# Bradley Heights Apartments

## A 236-Unit Apartment Development Puyallup, Washington

### Bradley Heights SS LLC

**1-BED-INT-1 UNIT** TYPE 'A' ACCESSIBLE  
BASEMENT & 1st LEVEL FLOOR PLAN  
1/4" = 1'-0"

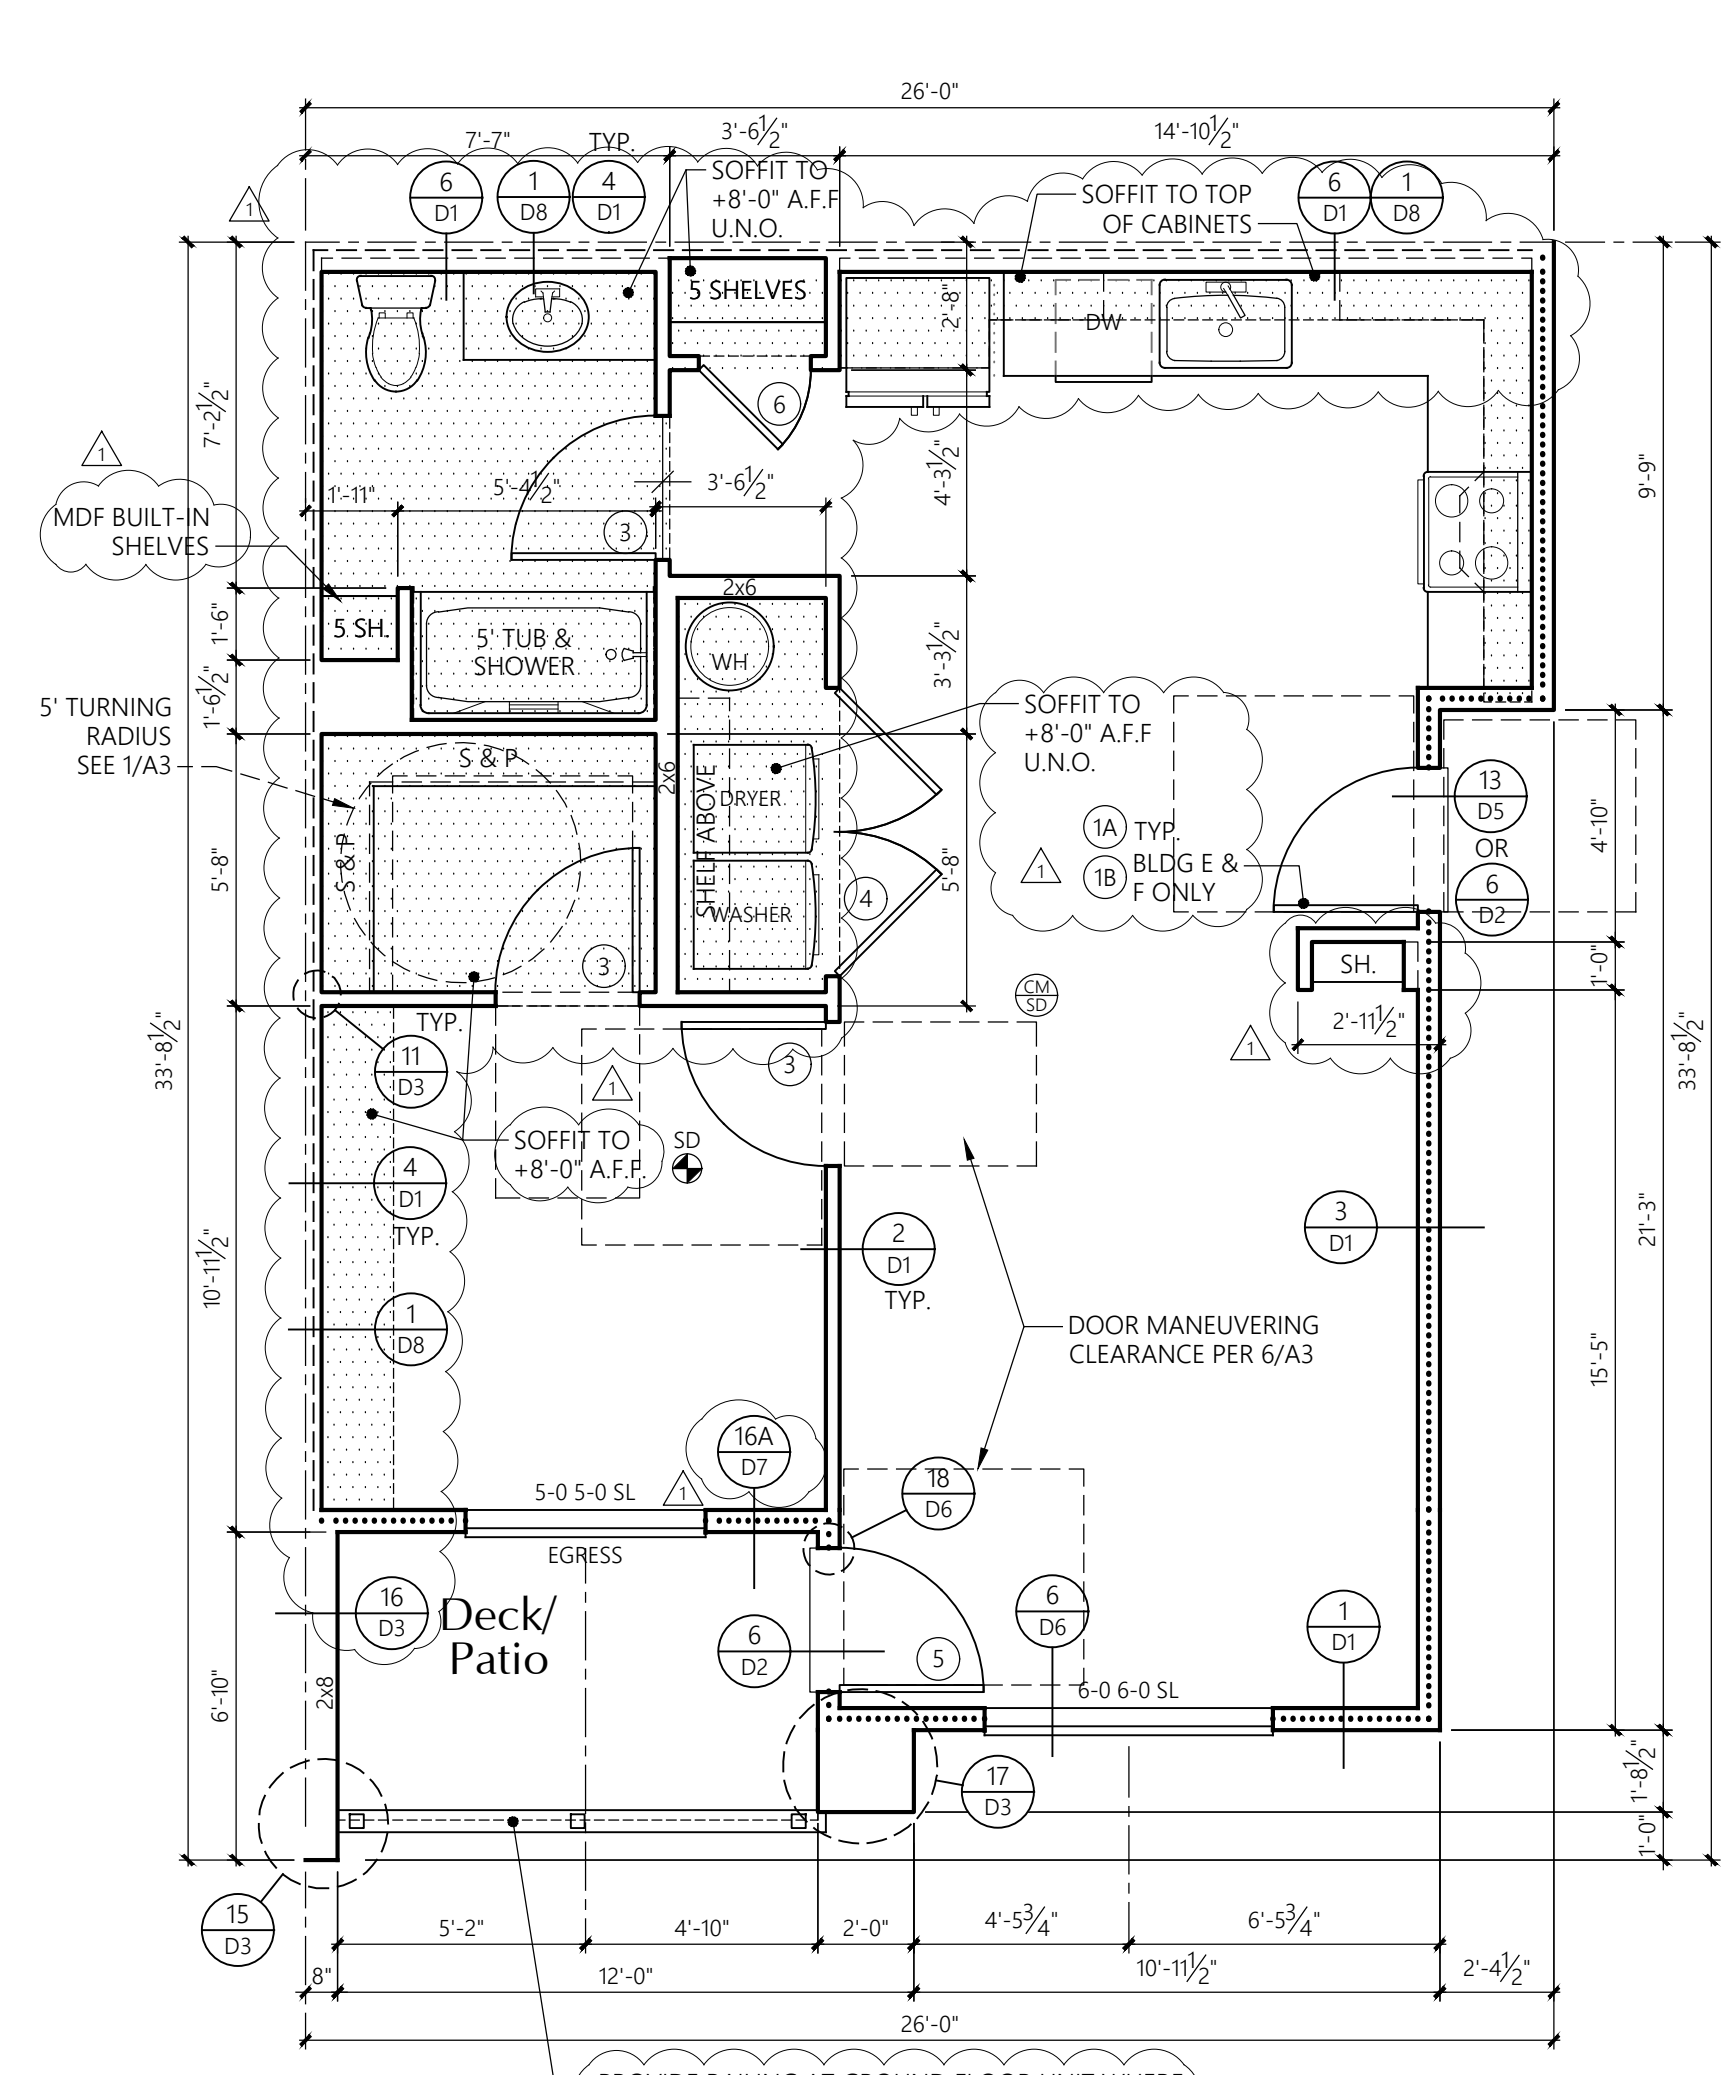
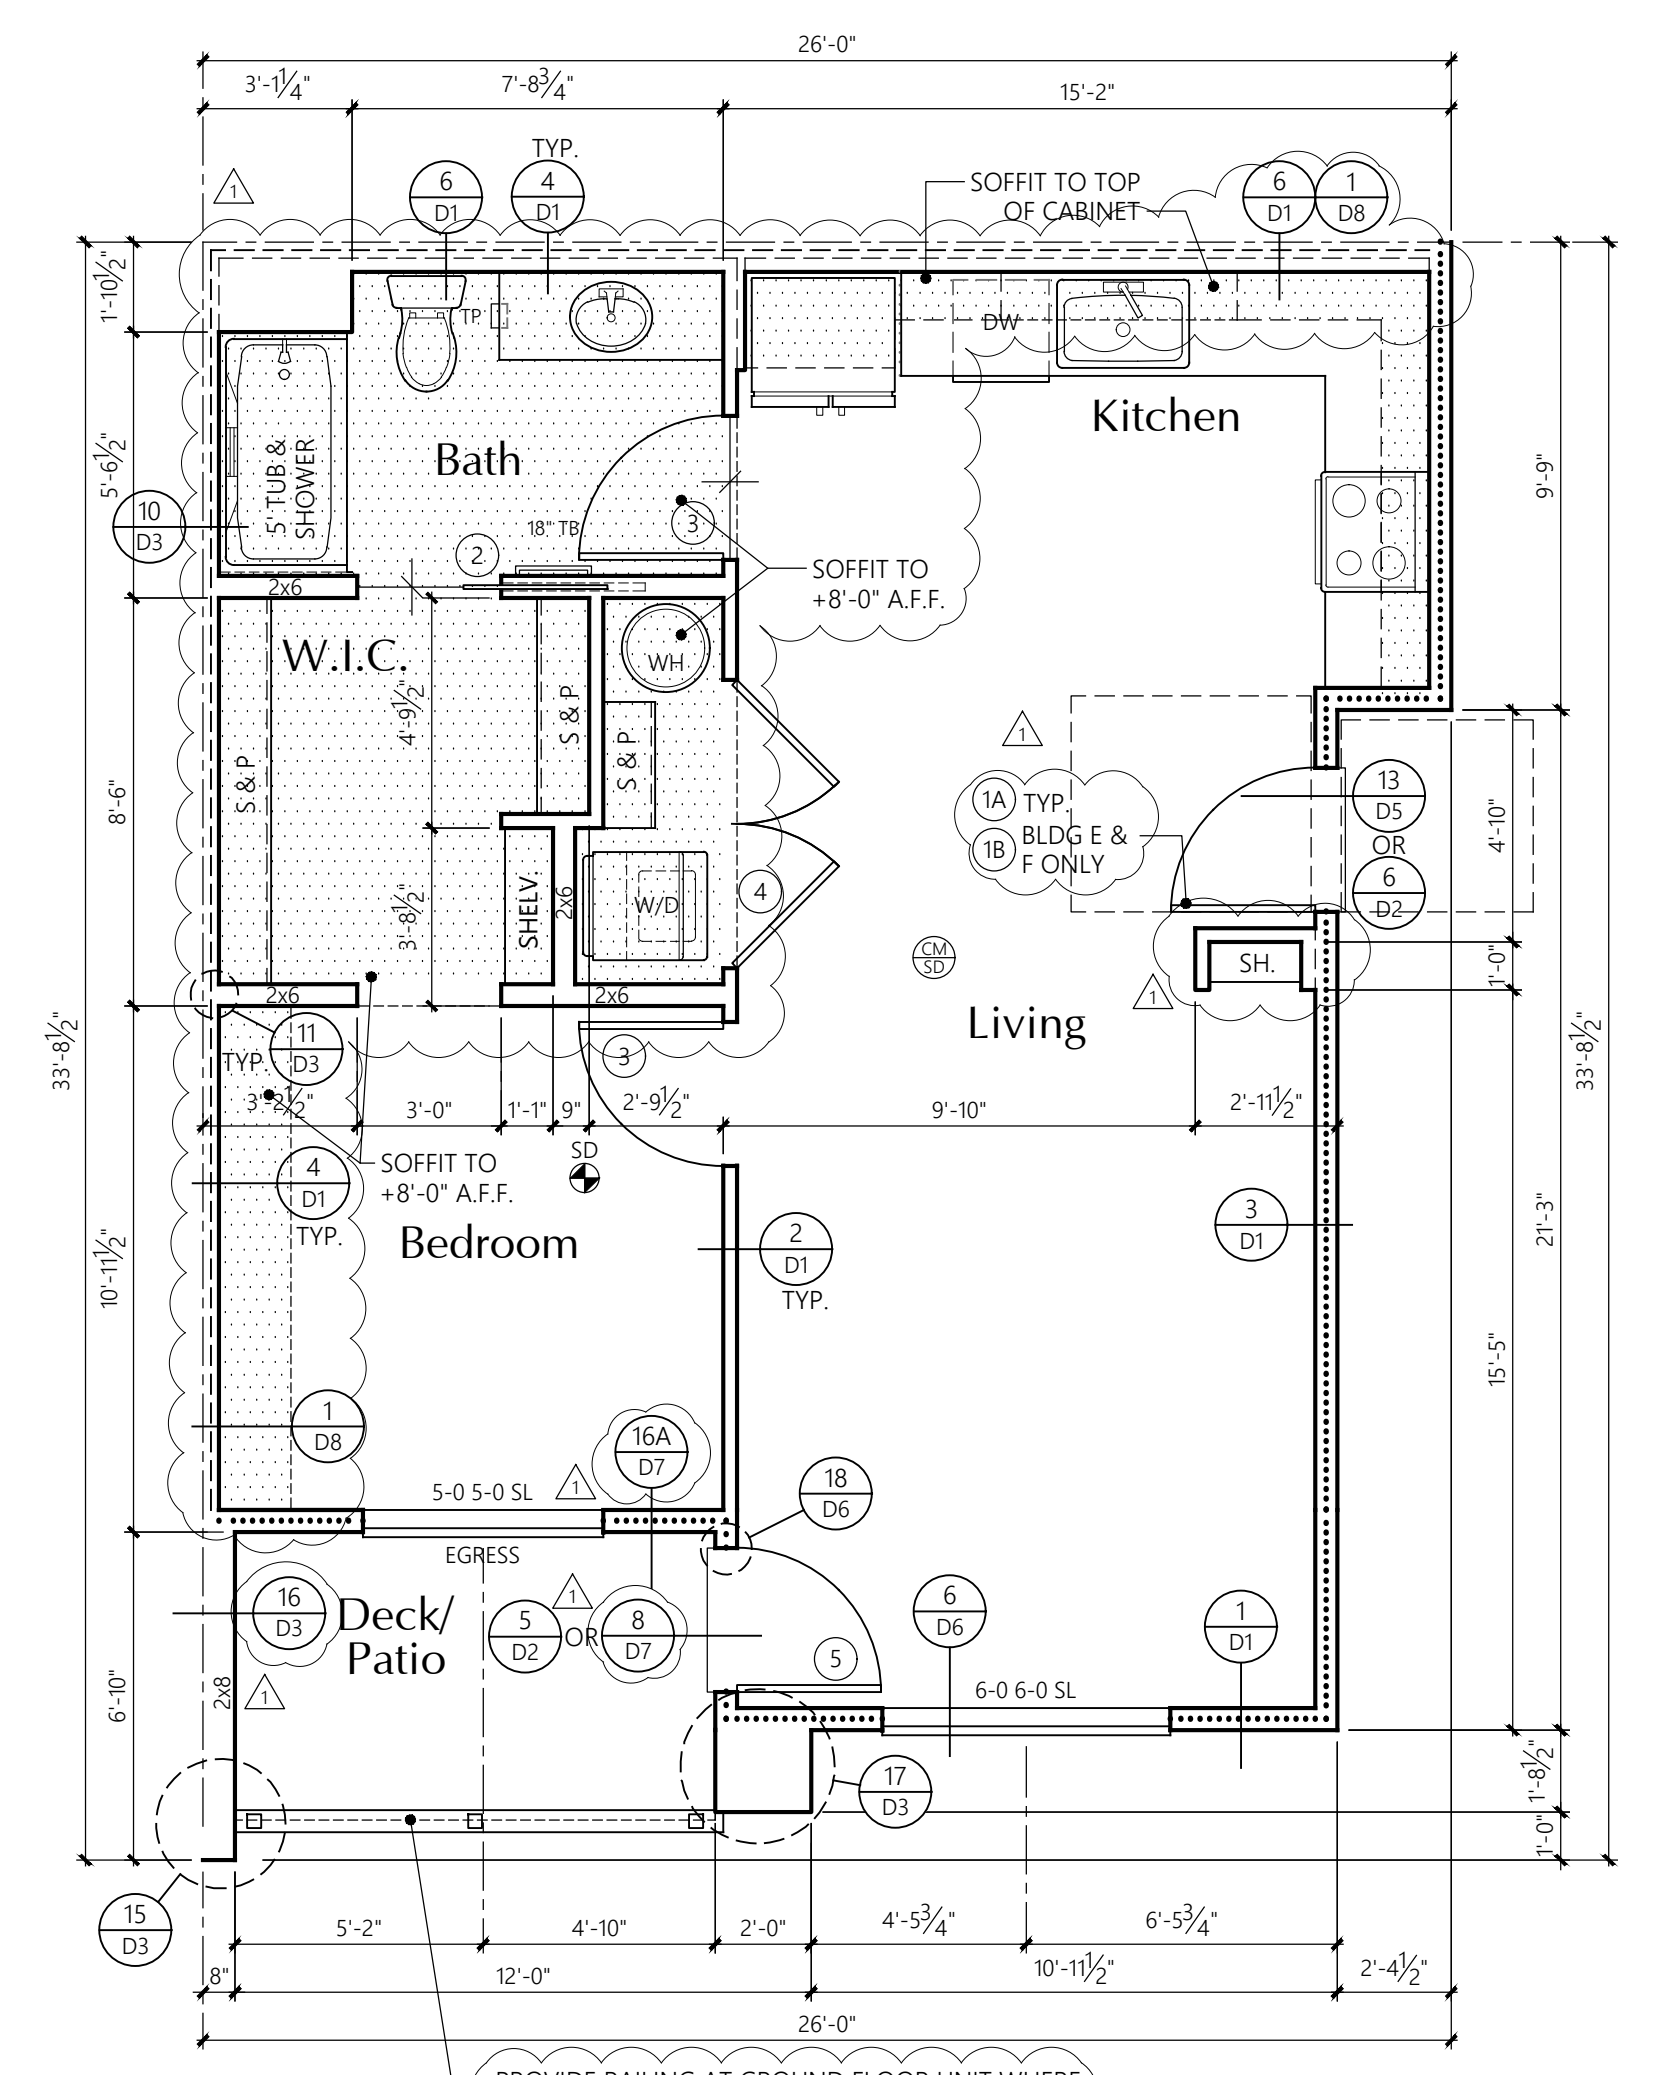
Review and clarify how washer and dryer in all Type A units shall meet Washington Accessibility Code 2009, Section 611. Example 2 Bed Unit shows a washer and dryer that appear to be stackable which could put the loading openings outside the perimeters set by 611.4. Review and updated as needed.  
(Construction Set, Sheet U1-U6, Unit Plan Plans)

Unit Plan Notes state that no plumbing shall be located in the 1" air gap. See plumbing plans plumbing multiple penetrations are being made within the 1" air gap. Coordinate drawings for consistency and ease of construction.  
(Construction Set, Sheet U1-U5.1, Unit Plan Notes)

Unit Plan Notes identify that R-13 insulation will be provided on 1 side U.N.O., but detail 4/D1 states to insulate both sides U.N.O. Please clarify if the wall will be insulated on both sides or one side only.  
(Construction Set, Sheet U1-U5.1, Unit Plan Notes)

Door Key references Sheet U13 update plan or sheet numbers as needed, as there is no Sheet U13.  
(Construction Set, Sheet U1-U5.1, Door Key)

**2-BED UNIT**

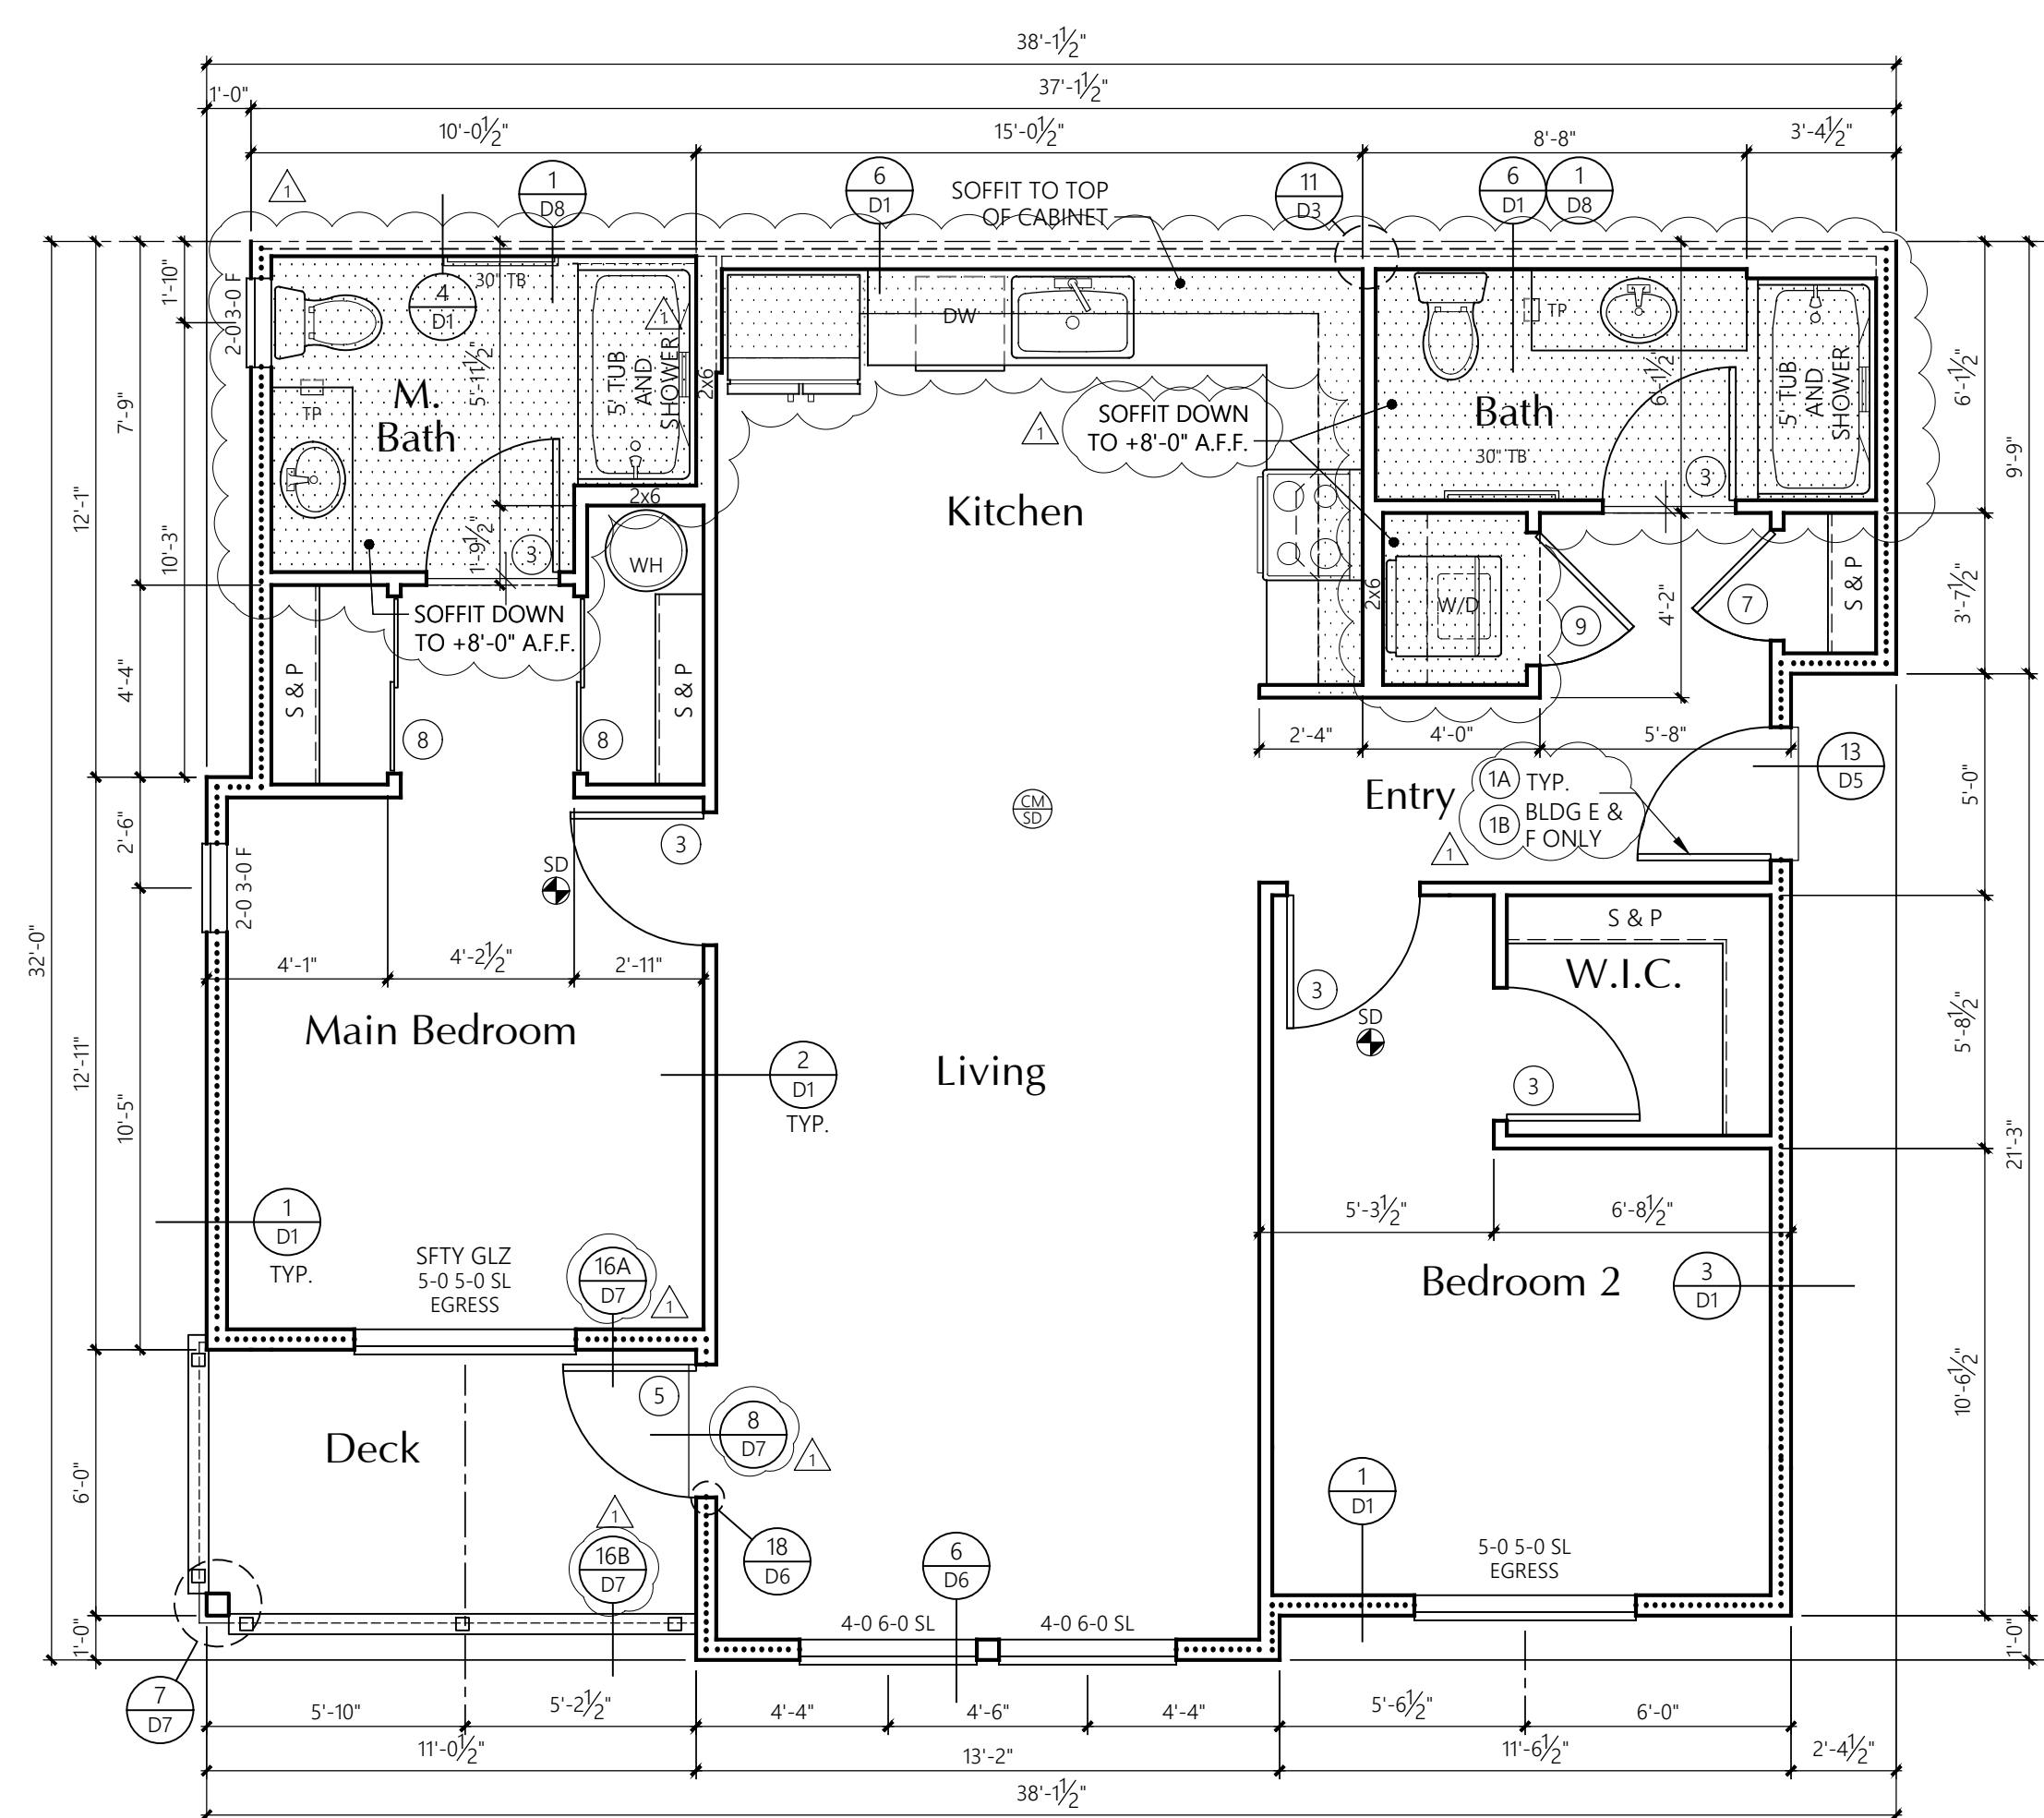
Review and clarify instances where header height will change as the header height is called out as 8' U.N.O. in Unit Plan Notes. Example 2 Bed Unit on Sheet U4 has a furrowed down ceiling. Review other units for additional instances and adjust if necessary.
